Timberline Tempering Mixing Valve

Bulletin Type:	Recall	Publication Date:	May 2026
Bulletin #(s):	26V-267	Make(s):	Jayco & Entegra Coach
Job Code(s):	9903654A - .10 HR Inspection only	Model(s):	Granite Ridge & Condor
Flat Rate(s):	9903654B – 1.0 HR Inspection and Installation of Timberline Tempering Mixing Valve	Model Year(s):	2026

Incident:	Elwell Timberline Hydronic Heating System installed without the tempering mixing valve.
Affected Units:	2026 Jayco Granite Ridge & 2026 Entegra Coach Condor
Parts Kit:26V-267	Parts Kit #: 26V-267 1 Qty - TEE,.50BARBX.50BARBX.50BARB *L 3 Qty - ELBOW,.50BARBX.50BARB PLSTC*G 1 Qty - ELBOW,.50BARBX.50MPT PLSTC *N 3 Qty - FITTING,.50BARBX.50MPT PLSTC *B 1 Qty - CONNECTOR,SWVL .50FPT *AC PLSTC W/WG 2 Qty - ELBOW,SWVL .50BRBX.50FPT *EM RADEL PLSTC W/WING .4' - HOSE,PVC BLU 0.50X500' HI-PRESS REINF .5' - HOSE,PVC RED 0.50X500' HI-PRESS REINF 1 Qty - VALVE,MIXING 1 Qty - RESTRICTOR,INLINE NEOPERL 1.0 GPM .50FPT TO .50MPT
Misc. Tools & Supplies:	Screw gun with Square Head Bit Pliers Waterline Crimping Tool Cutters Teflon Tape/Plumbers Tape
Parts Return Information:	N/A

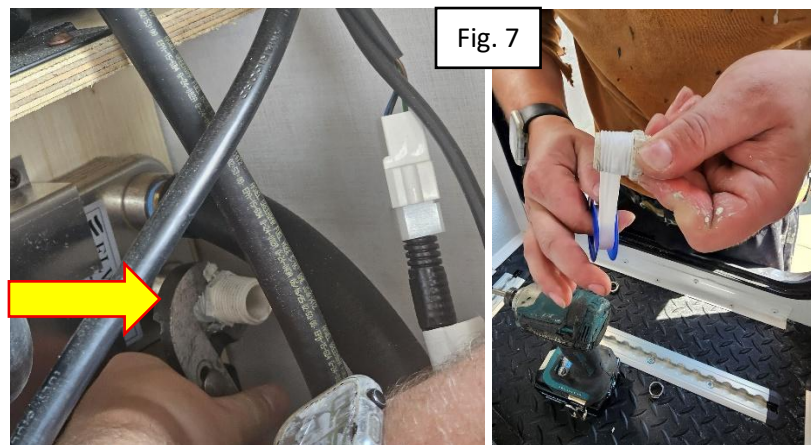
6. Cut the water lines approximately 3" to 3.5" below the elbow of the lines that were connected to the heat exchanger. (Figure 6)

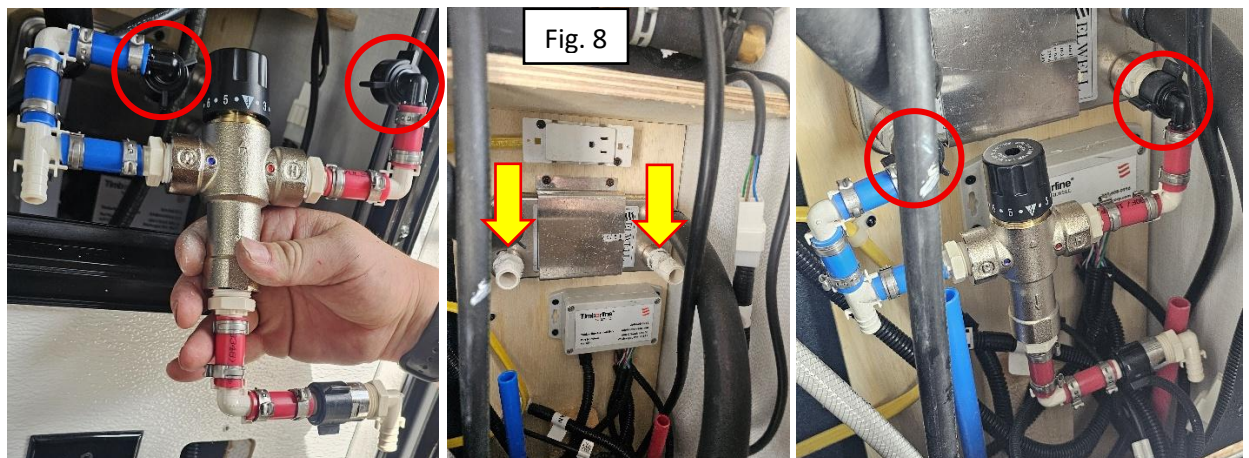
7. Use pliers to remove the connector from the heat exchanger, **on the hot line side only**, including the flow restrictor. With the flow restrictor removed, apply plumber's tape/teflon tape to the connector and re-install it into the heat exchanger.
- a. **NOTE: You can discard the flow restrictor that was removed from the heat exchanger. A flow restrictor will be included in the mixing valve assembly provided for the repair.** (Figure 7)

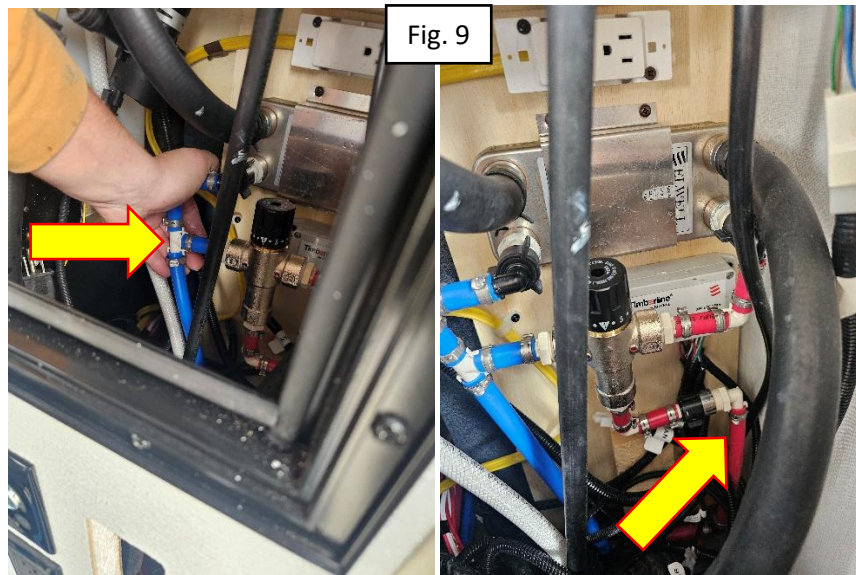
8. Connect the hot and cold line elbows, from the supplied mixing valve assembly, to the heat exchanger in the coach. (Figure 8)

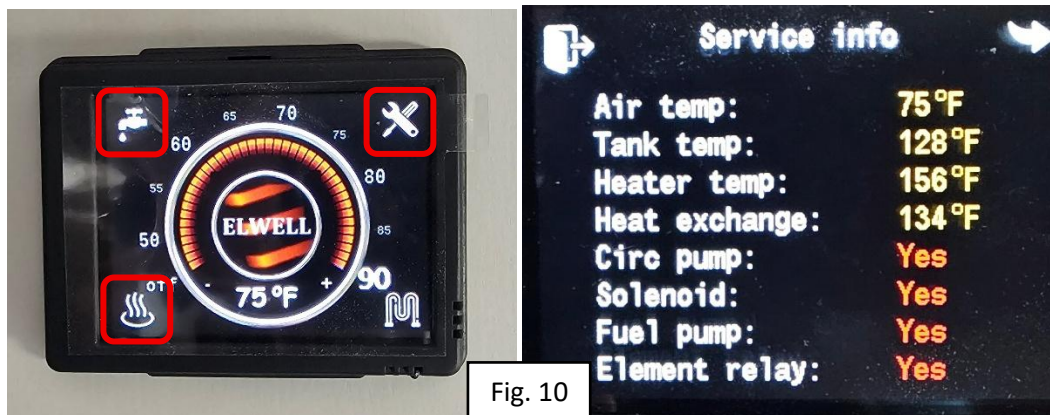
9. Connect the hot and cold water lines with the pex connectors, in the supplied valve assembly, and use a crimping tool & crimp to fully secure the lines. (Figure 9)
